UNSHINAGH AVIATION LIGHTING SCHEME

DRAWING NUMBER
04291-RES-LAY-DR-TE-034

Proposed Obstacle Lighting Scheme for Unshinagh Wind Farm

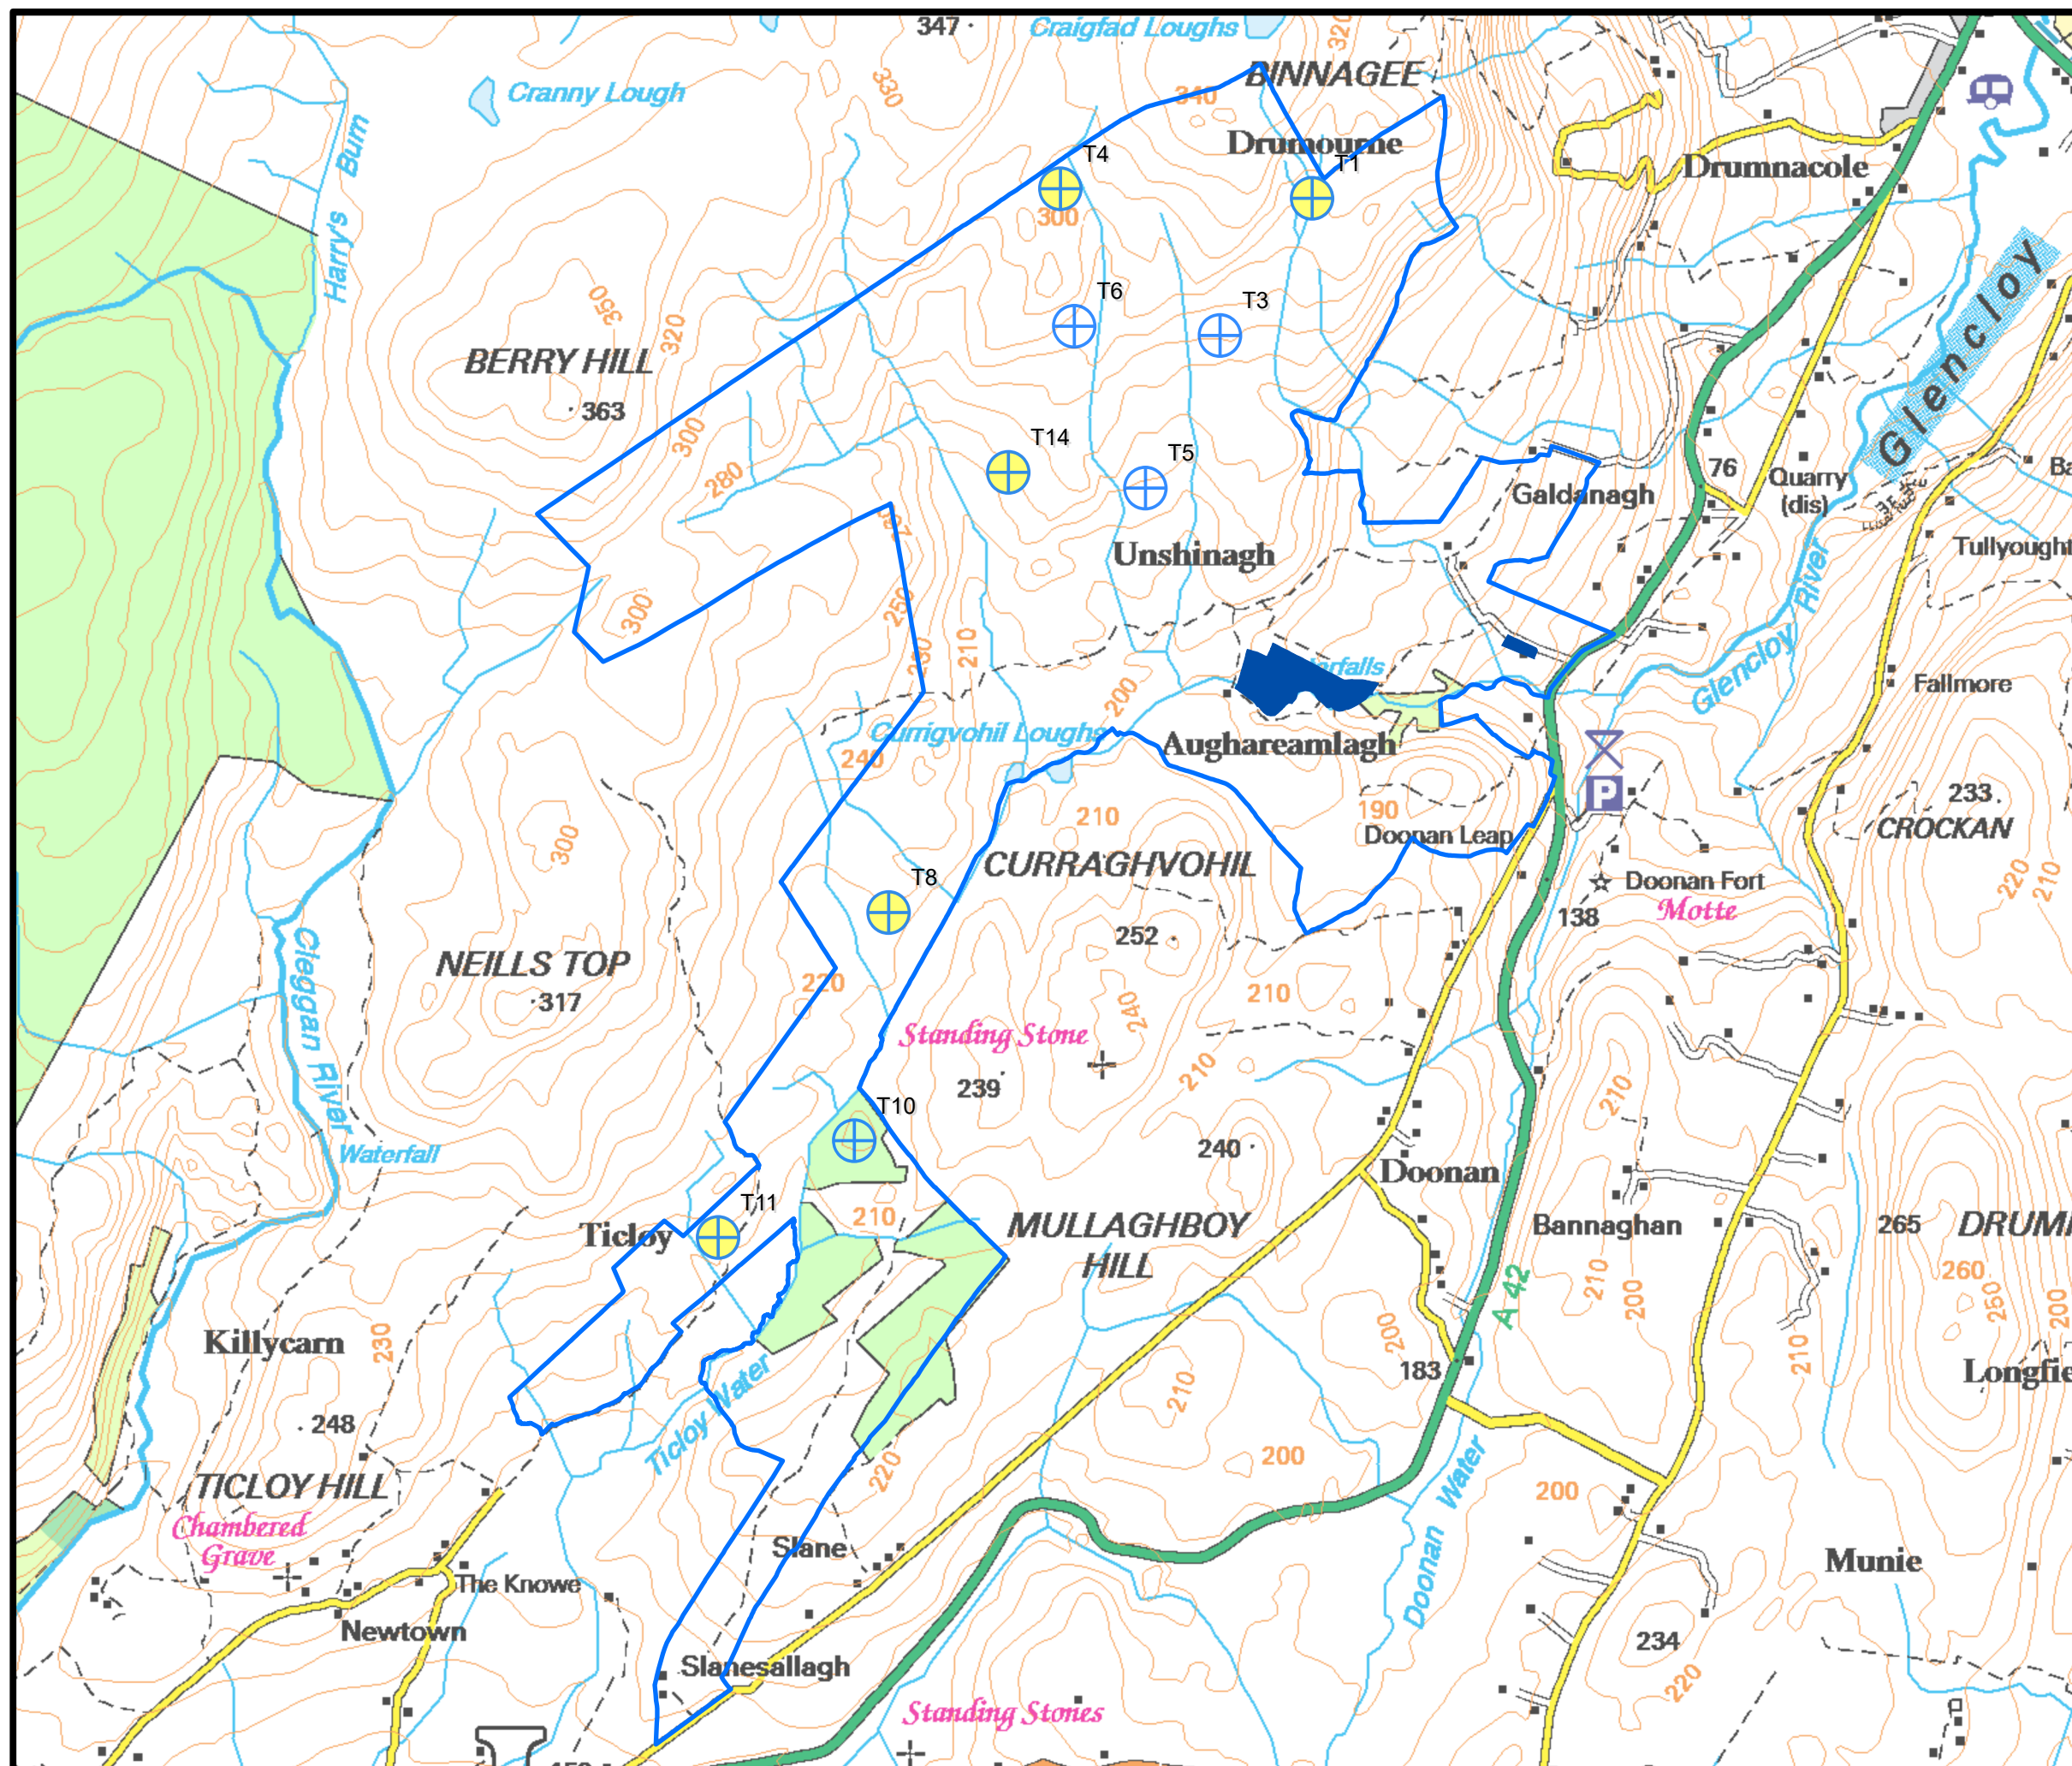
Discussions to date with the CAA have indicated that it will not be necessary to illuminate all turbines.

To maintain air safety in the area, it is suggested that it will be sufficient to install aviation lights on 5 of the 9 turbines.

Turbines T1, T4, T8, T11 and T14 are shown as lit in this figure.

5. Under provisions given in the Air Navigation Order (ANO) Article 222 section 6, the CAA provides for the following variation:
 - medium intensity steady red (2000 candela) lights on the nacelles of turbines T01, T04, T08, T11 and T14;

- a second 2000 candela light on the nacelles of the above turbines to act as alternates in the event of a failure of the main light (note that both lights should not be lit at the same time);

- the lights on these turbines to be capable of being dimmed to 10% of peak intensity when the lowest visibility as measured at suitable points around the wind farm by visibility measuring devices exceeds 5 km;

- a scheme of infra-red lights to MoD specification to be agreed with MoD (note that dimming permission is applicable only to visible lights, not infra-red lighting).

6. Intermediate level 32 candela lights are not required to be fitted on the turbine towers.
